PG&E Letter DCL-02-115

Docket No. 50-275i, OL-DPR-80  
Docket No. 50-32i, OL-DPR-82  
Diablo Canyon Units 1 and 2  
License Amendment Request (LAR) 01-08  
Credit for Automatic Actuation of Pressurizer Power Operated Relief Valves:  
Pressurizer Safety Valve Loop Seal Temperature

**LICENSE AMENDMENT REQUEST FOR DIABLO CANYON POWER PLANT  
CREDIT FOR AUTOMATIC ACTUATION OF PRESSURIZER POWER OPERATED  
RELIEF VALVES; PRESSURIZER SAFETY VALVE LOOP SEAL TEMPERATURE**

Figure 2: Pressurizer Overfill Analysis – Pressurizer Pressure

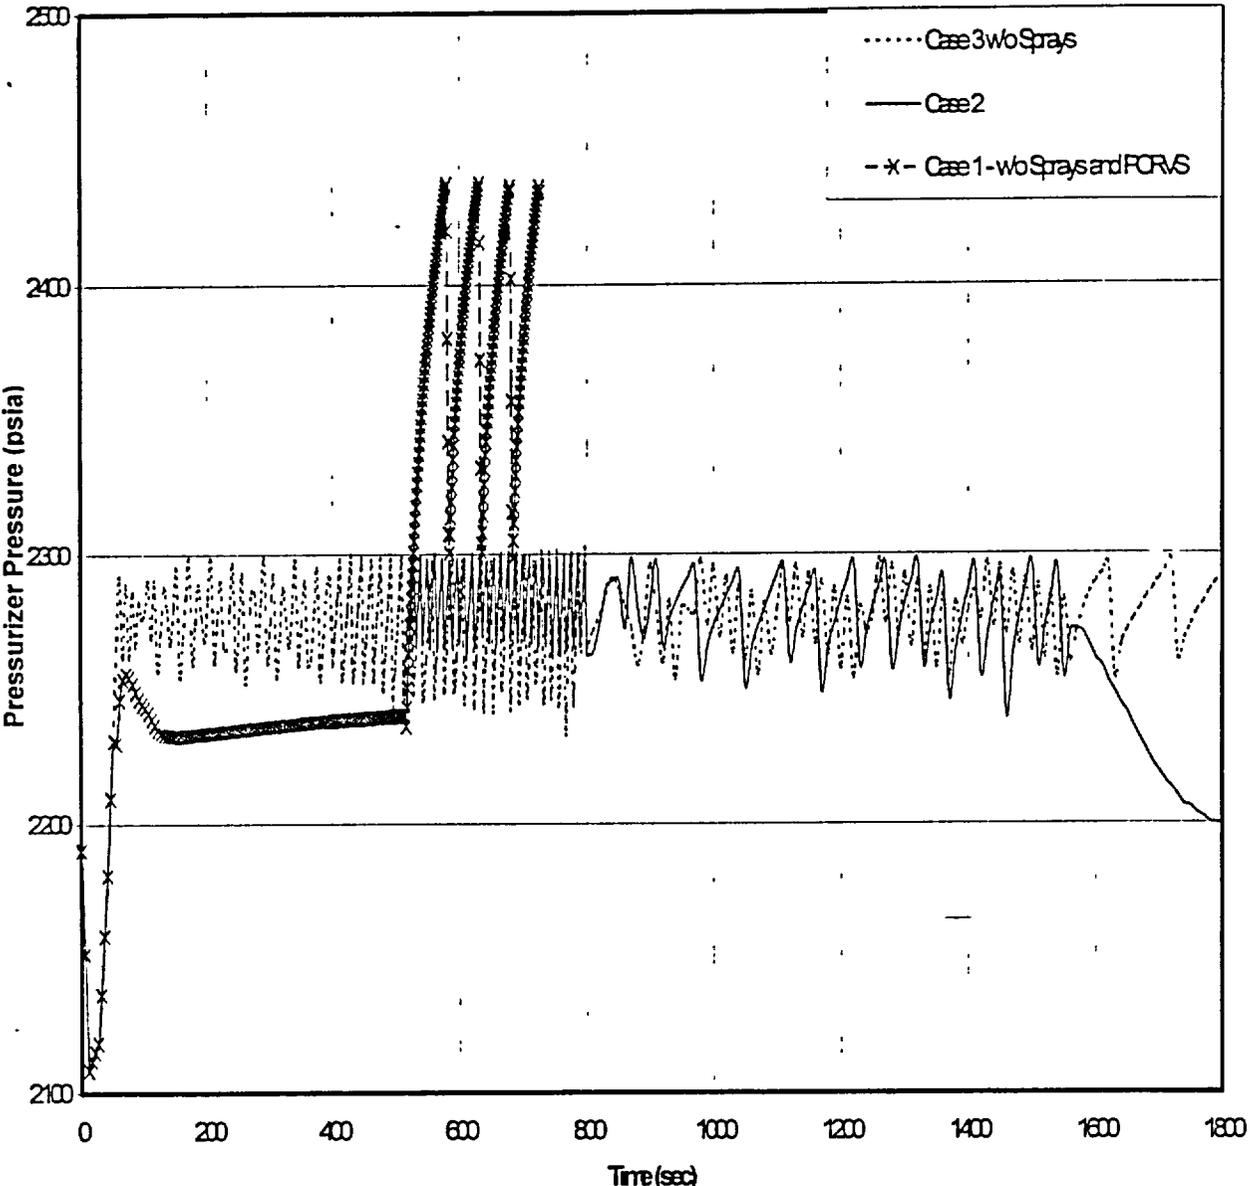
The sequence of events for each of the three pressurizer overfill cases are listed in Table 1. The transient responses are shown in Figures 2 through 4.

The spurious SI signal occurs at one second. This generates a concurrent reactor trip signal from full power conditions followed by a turbine trip signal one second later. The pressurizer pressure and pressurizer level initially decrease as the RCS power and temperature

reduce from full power conditions to hot no load conditions. The initiation of the ECCS injection flow then rapidly increases the pressure until the pressurizer spray valves open enough to maintain the pressurizer pressure relatively constant. The pressurizer level continues to increase due to ECCS injection flow and pressurizer spray flow until the pressurizer fills. The water solid RCS then experiences a rapid pressure increase to the pressurizer safety valve lift setpoint. The Case 1 analysis evaluation is considered complete when the fourth liquid relief of the PSV begins at 726 seconds. This establishes the limiting time available for the operators to unblock a pressurizer PORV to prevent challenging the liquid relief capability of the PSV.

Figure 3: Pressurizer Overfill Analysis – Pressurizer Liquid Volume

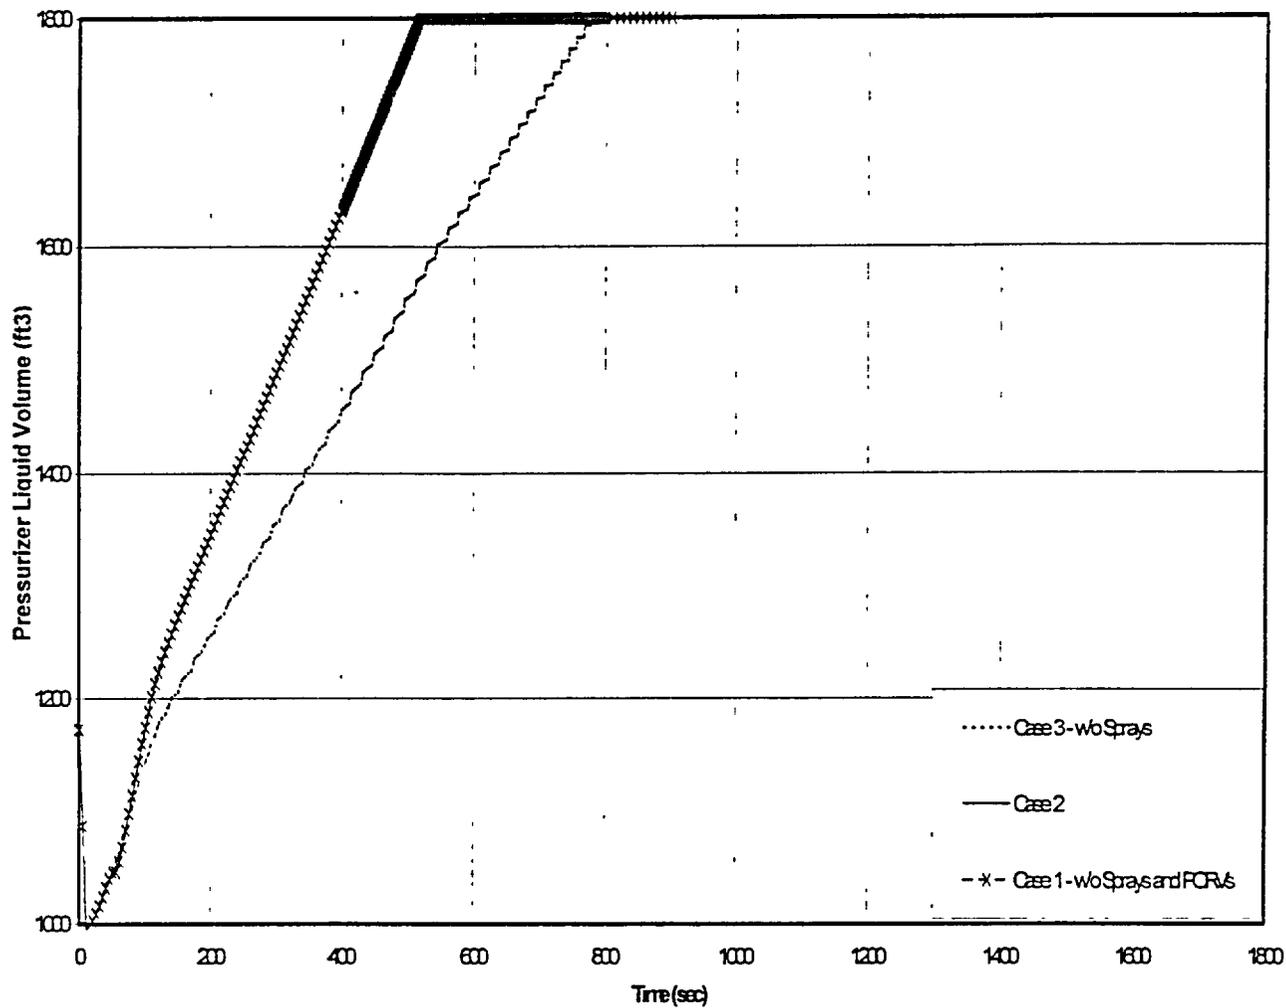
The first part of each spurious operation of the SI system at power case is essentially identical as the plant experiences the spurious SI actuation, reactor trip, and turbine trip from full power conditions. The plant response for Case 2 is identical to Case 1 up to the time that the pressurizer becomes water solid. For Case 2, the RCS pressure increases only to the pressurizer PORV lift setpoint where it is maintained relatively constant as the PORV continues to cycle and relieve liquid. As the operator actions decrease the ECCS injection flow, the PORV begins cycling less frequently. By the time the spurious operation of the SI system at power event is terminated at 30 minutes, the PORV has cycled a total of 45 times.

Figure 4: Pressurizer Overfill Analysis – RCS Average Temperature

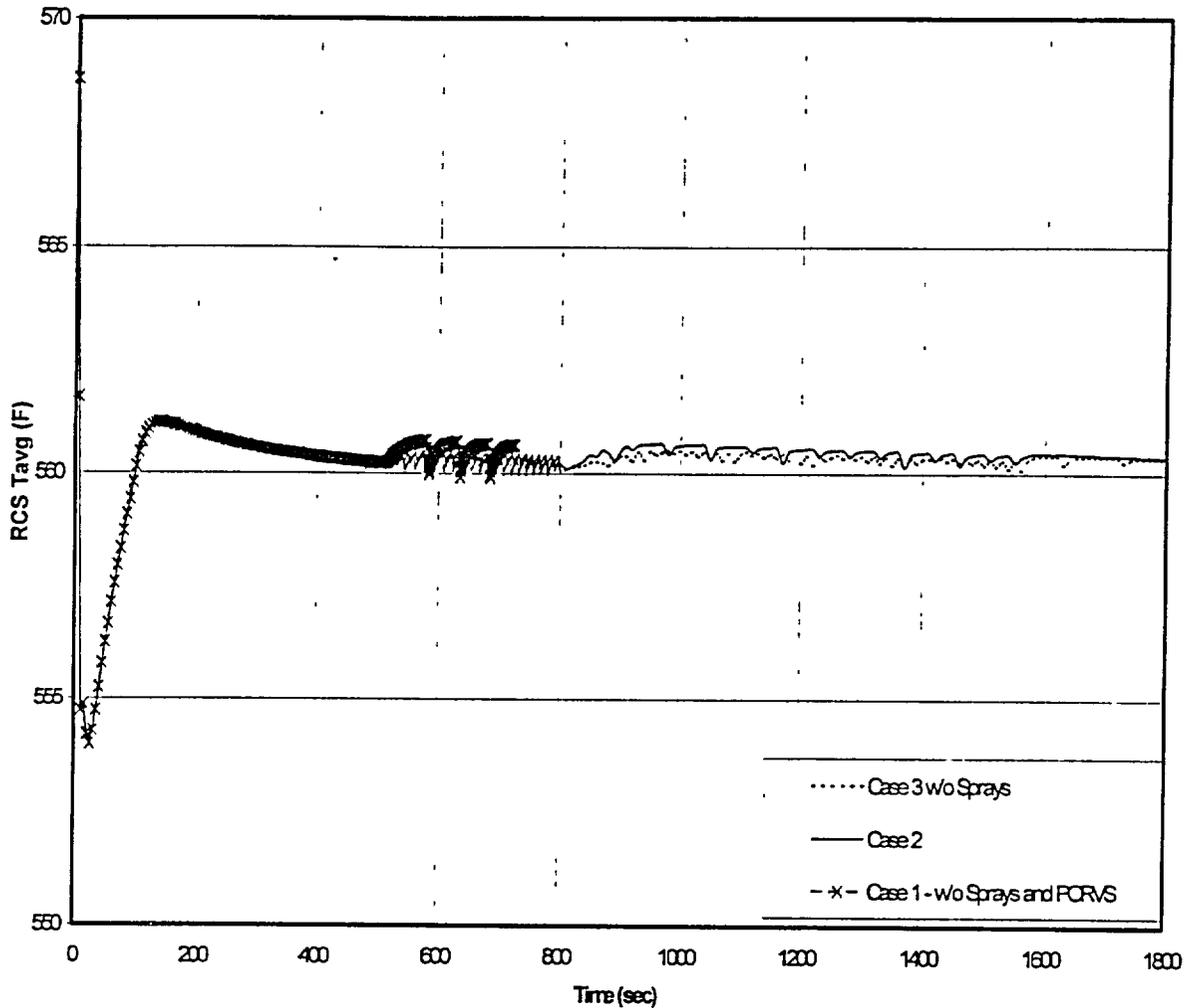
In Case 3, the pressurizer sprays are not available such that after the reactor trip the RCS pressure continues increasing to the pressurizer PORV lift setpoint. The pressurizer PORV continues to cycle and relieve steam as the pressurizer level increases due to the ECCS injection flow. Without the pressurizer sprays, the RCS pressure is maintained near the PORV setpoint and the pressurizer fills later than Case 1. Once the pressurizer becomes water solid, the PORV begins relieving liquid. Due to the greater mass flow rate, the PORV cycles at a slightly faster rate when relieving liquid than when relieving steam. Similar to Case 2, the PORV begins cycling less frequently as operator actions decrease the ECCS injection flow. By the time the spurious operation of the SI system at power event is terminated at 26 minutes, the PORV has cycled a total of 93 times.

Figure 1

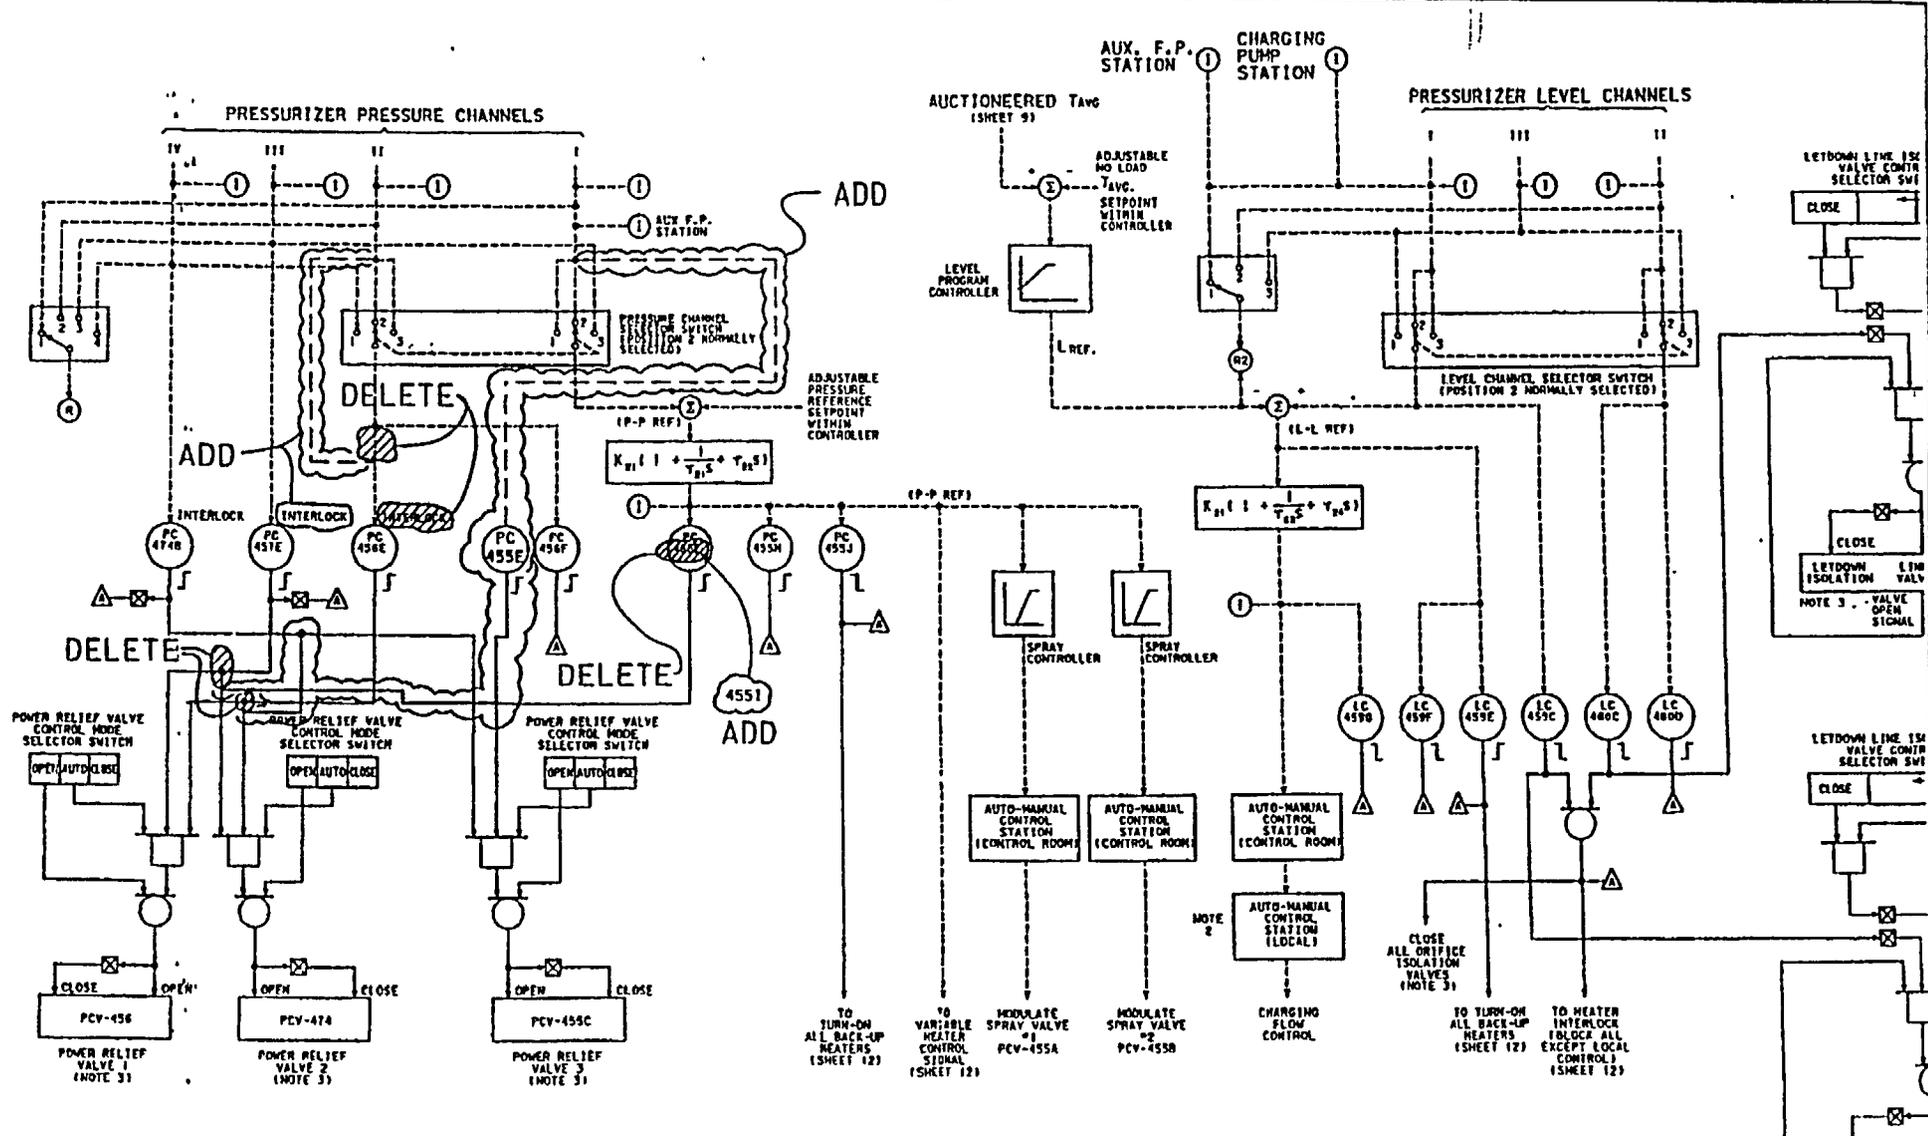
Currently, part of the automatic control circuitry for the Class 1 PORVs downstream of the reactor protection system (Eagle 21 process protection system) is Instrument Class II, i.e., Instrument Class II Hagan Model 118 bistable comparator modules in the control racks actuate the PORV auxiliary relays. To allow credit to be taken for the Class 1 PORVs for safety related functions, the automatic actuation circuitry will be upgraded to actuate the Class 1 PORV auxiliary relays directly from the Eagle 21 process protection system (Eagle partial trip (EPT) card outputs will actuate the PORV actuation and interlock relays). The EPT cards will be reconfigured to support an energize-to-trip function. Separation and isolation requirements will be maintained in implementation of the new design. See Figure 1.

Similar to the current design, two pressure protection channels will control each Class 1 PORV. One pressure channel provides input for an open permissive signal (> 2185 psig) serving as an interlock that blocks automatic opening of the PORV when the pressure is below the setpoint. In the absence of the low pressure interlock condition, the second pressure channel opens the PORV at the nominal high pressure setpoint of 2335 psig.
